## SUBMITTAL SUMMARY REPORT 30535

**PLAN NAME:** NEXT DIMENSION CONSTRUCTION      **LOCATION:** 15878 S US HWY 441  
**APPLICATION DATE:** 08/21/2023      **PARCEL:** SUMMERFIELD,  
47696-000-01

**OCE: Plan Review (DR) v.1**

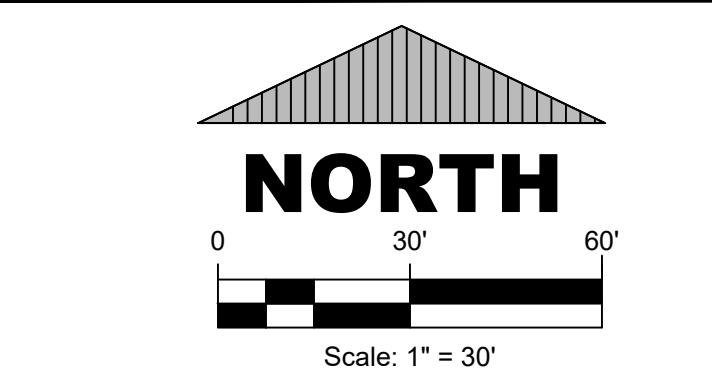
YES 2.12.8 - Legal description matches boundary on plan  
NO 2.12.28 - Correct road names supplied Sheet C100 – Site Plan is missing the road name label for S US HWY 441 and SE 93rd Avenue Rd. Sheet C700 has S US HWY 441 incorrectly labeled as SR 500 (US 441/ us 27).  
YES 6.2.1.F - North arrow and graphic drawing and written scale  
INFO Additional 911 comments Please be advised that when the building permits are submitted the addresses assigned including the unit numbering will not match the units listed on the plan.

**UTILITY PLAN**

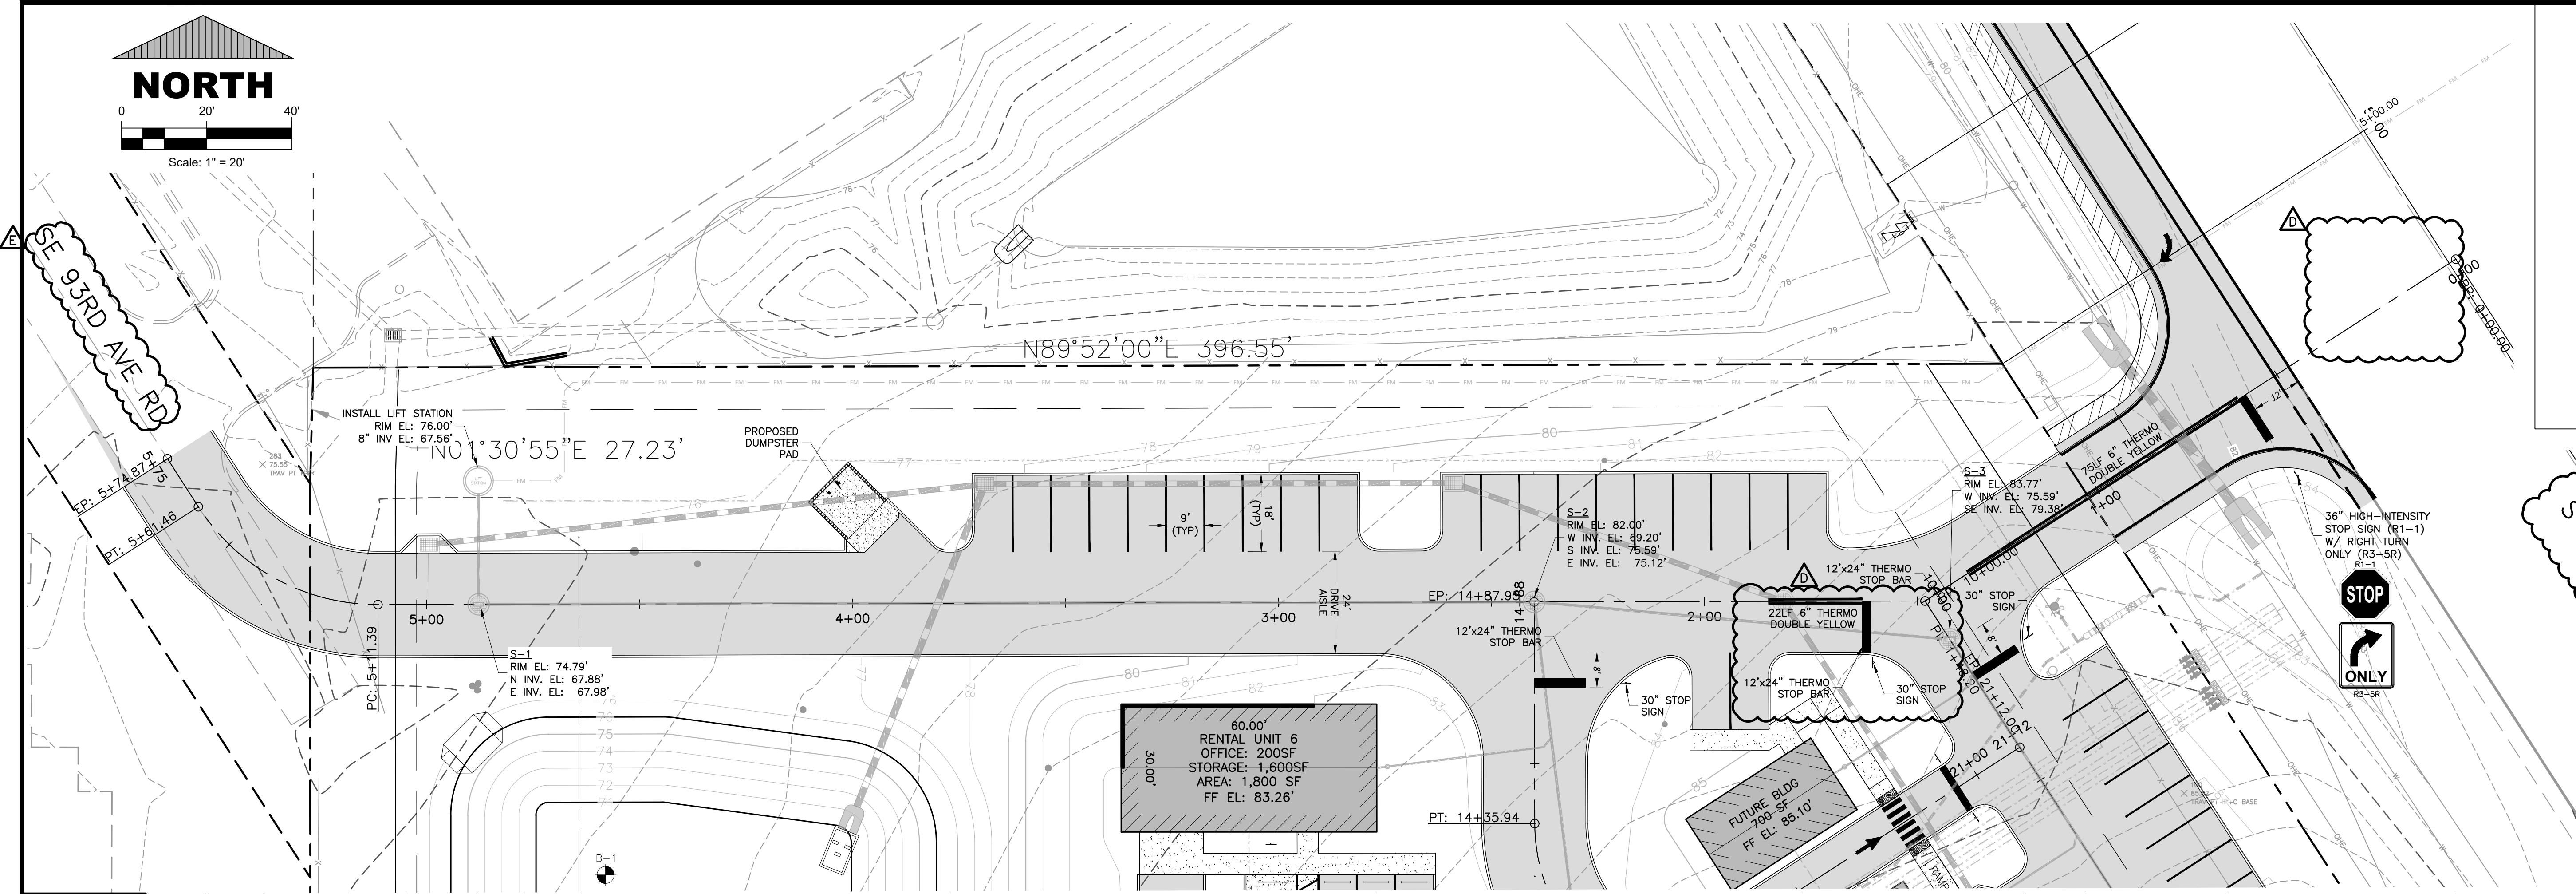
YES 6.14.5.A(8) - Submittal Requirements - Connection to existing water system 4.16.25 - Acknowledged and changed. see changemarks on sheet C102 for connection notes

YES 6.14.5.A(8) - Submittal Requirements - Connection to existing sanitary system 4.16.25 - Acknowledged and changed. see changemarks on sheet C102 for connection notes

YES 6.15.3 - Fire Protection/Fire Flow Capacity 6.2.25 - Corrected. Previous comment: 4.16.25 - C102 - Private hydrant must be downstream of DDC.

YES 6.15.4 - Water Main Piping Installation 6/2/25 Corrected. Previous Comment: C102- Confirm wet tap and Sewer Force Main meet minimum separation by the FDEP. (2) Taps must be a minimum of 24" apart for the six potable meters and RPZ's.

YES 6.15.5 - Water Service and Connection 6/2/25 Corrected. Previous Comment: C102 - Water connection/ taps cannot be under mitered end of culvert

YES 6.15.6.D - Meter Location 6/2/25 Corrected. Previous Comment: C102 - Confirm all meters are in the ROW or dedicated easement.

NO 6.15.6.F - Meter Boxes 7/28/2025 - Utility plan not uploaded, unable to clear comment. C102 - (1) Cloud reads 5 separate taps. There is 4 shown on the plans. Needs correction (2) Plans could show, two taps, with 5 meters on each to reduce taps into the water main.

YES 6.15.7 - Cross Connection Control and Backflow Prevention 4.16.25. C102 updated and note listed. Previous comment: Backflow preventer noted needs to be changed to Double Detector Check Valve on Sheet C102

YES 6.16.4 - Wastewater Collection Systems (Gravity/Pressurized) Design 6/2/25 Corrected. Previous Comment: C102 -Force main ARV must be built in accordance with UT316. (2) Identify FM size in call out box.

Recommendations	Potable Water Bacterial Sample Points are not pointing to the water lines. Need to change leader location.			
Recommendations	Commented multiple times. ARV does not go in valve box. Must be above ground. Will need to be a red line change in plans are approved with this submittal.			
Recommendations	Grease trap label shows on C102, but grease trap has been removed. Remove label.
